ADDENDUM NO. 1

Timmerman / MWC Support Pavement Rehabilitation

Project No. WA0276

Timmerman Airport (MWC)
9305 W Appleton Ave.
MILWAUKEE, WISCONSIN 53225

1
RM101
REMOVAL & EC LAYOUT PLAN
SCALE: 1" = 40'

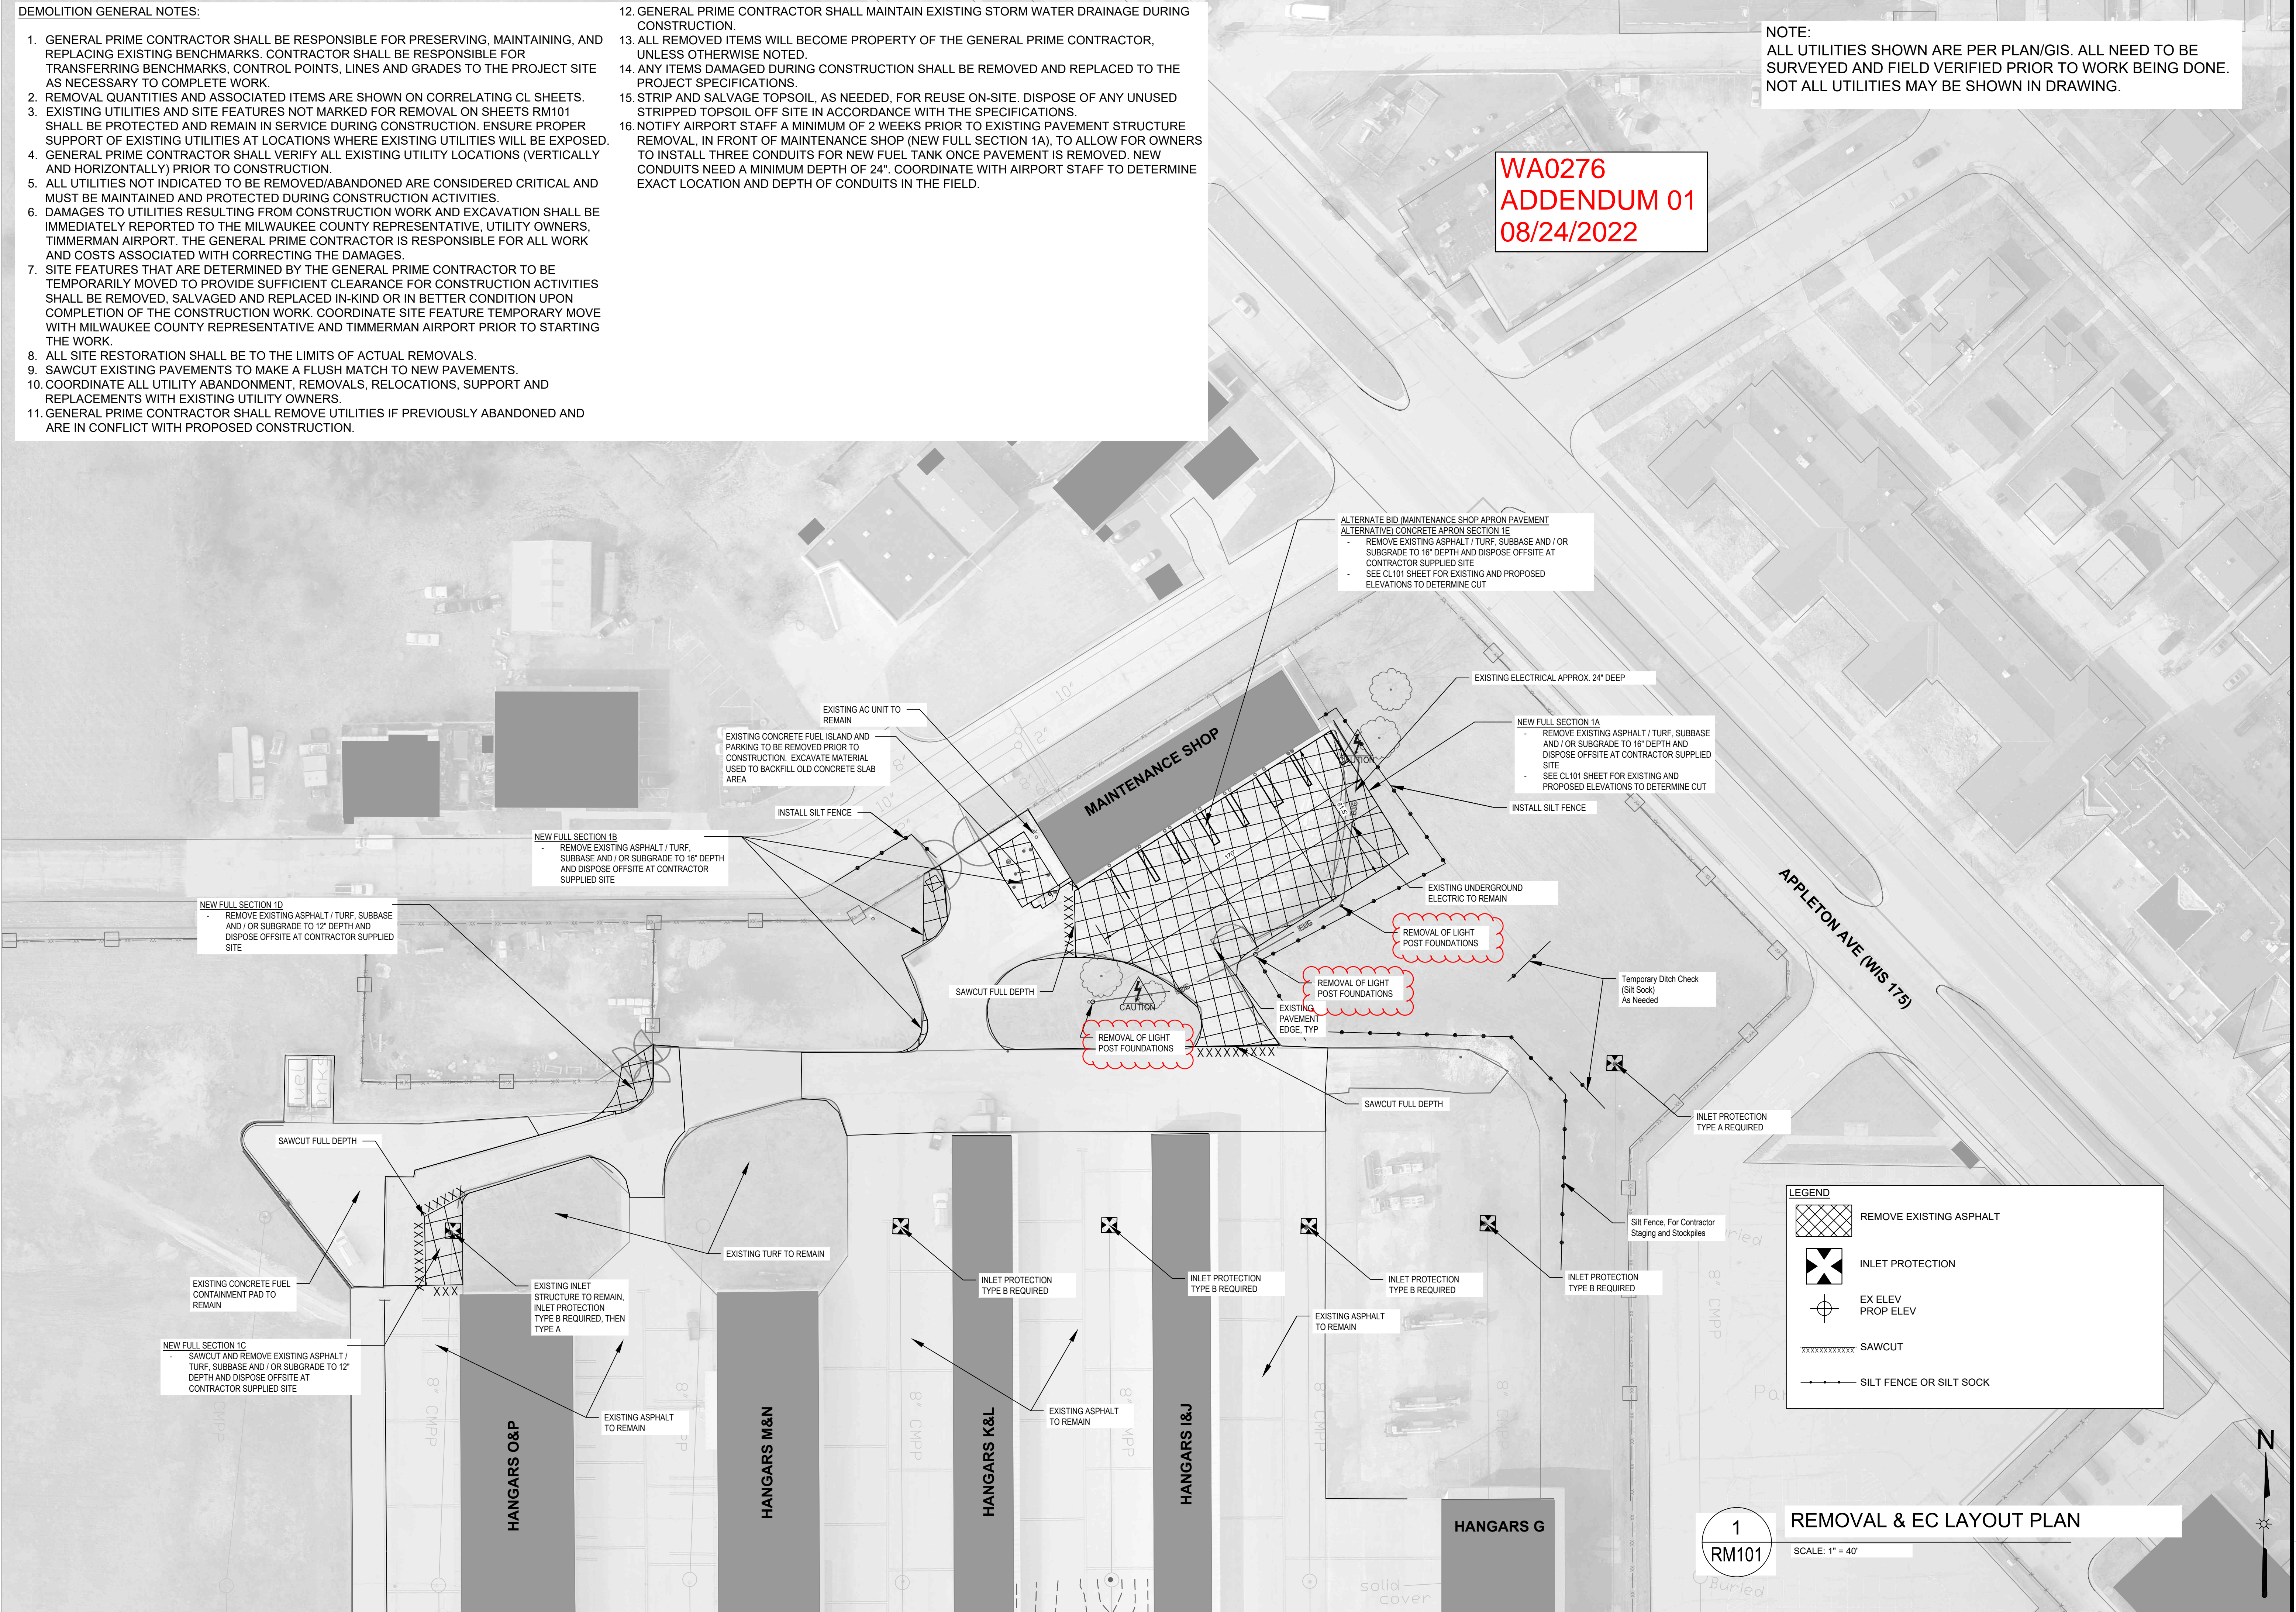
4.1 Sheet RM101:

UPDATE sheet with the attached sheet. Changes include removal of light pole bases.

**1
CL104** CIVIL LAYOUT PLAN
SCALE: 1" = 40'

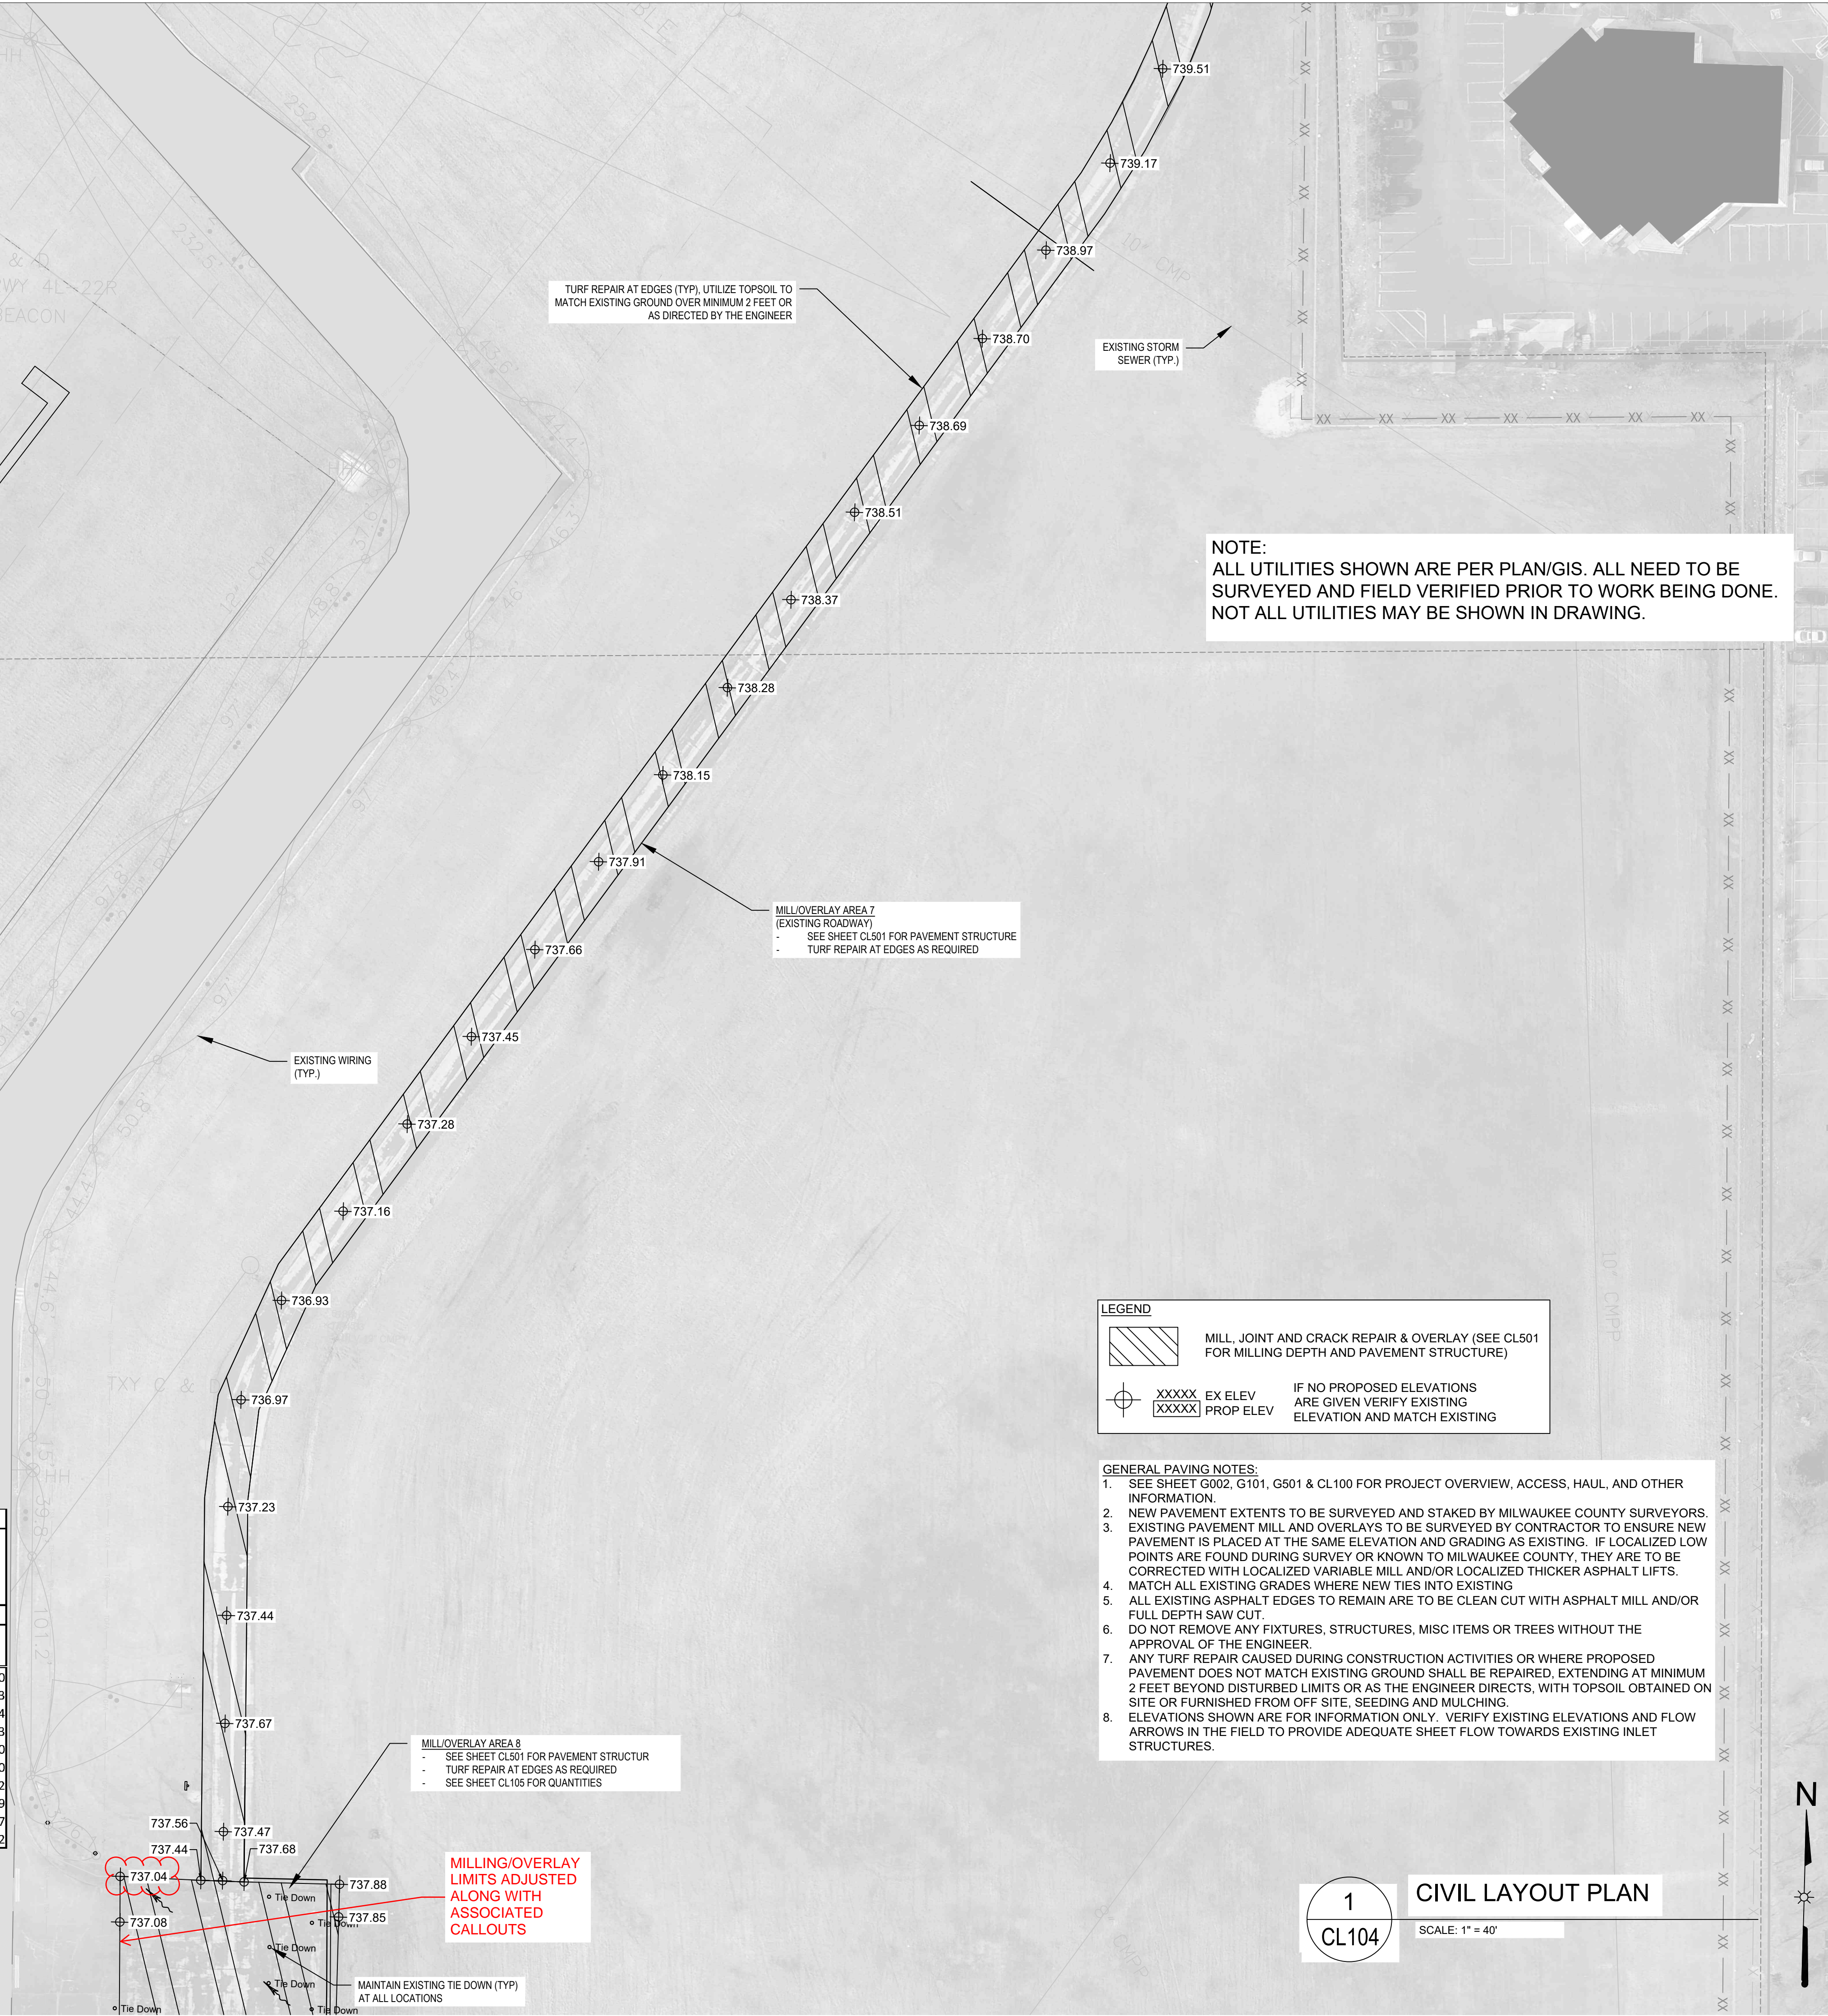
4.4 Sheet CL104:

UPDATE sheet with the attached sheet. Changes include Milling/Overlay limits adjustment along with associated callouts.

MILLING/OVERLAY LIMITS ADJUSTED ALONG WITH ASSOCIATED CALLOUTS

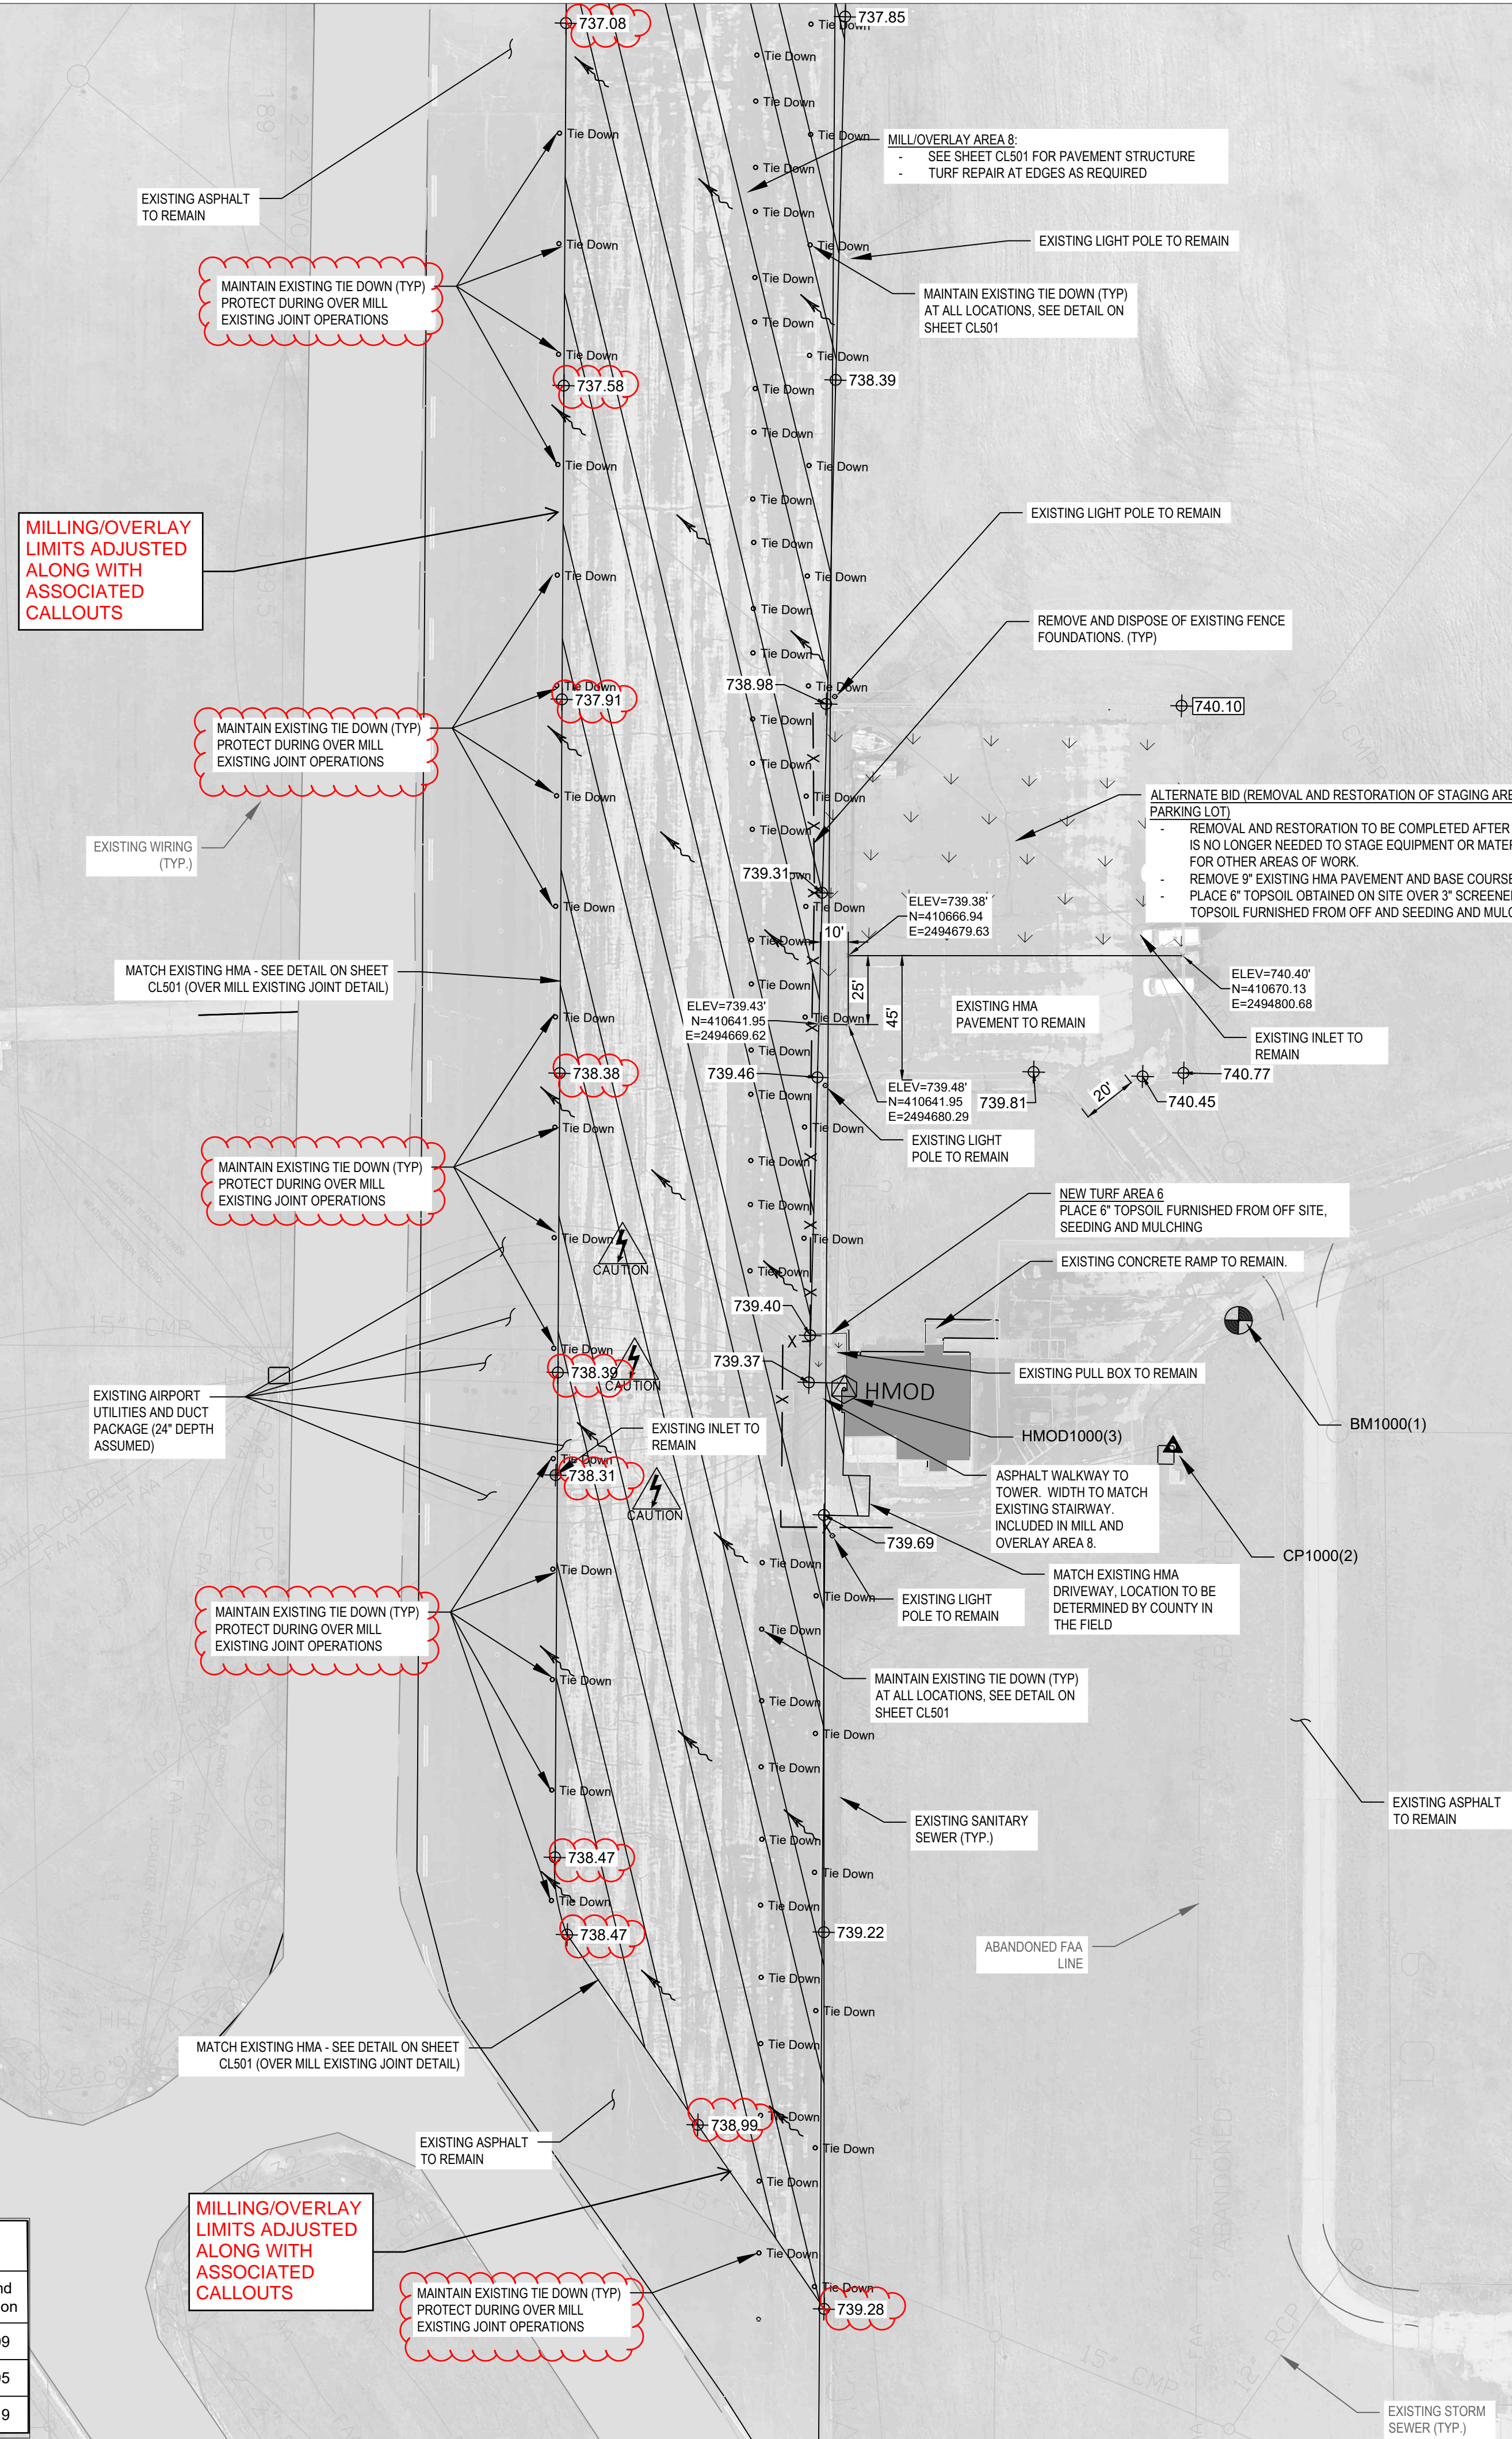
4.5 Sheet CL105:

UPDATE sheet with the attached sheet. Changes include Milling/Overlay limits adjustment along with associated callouts.
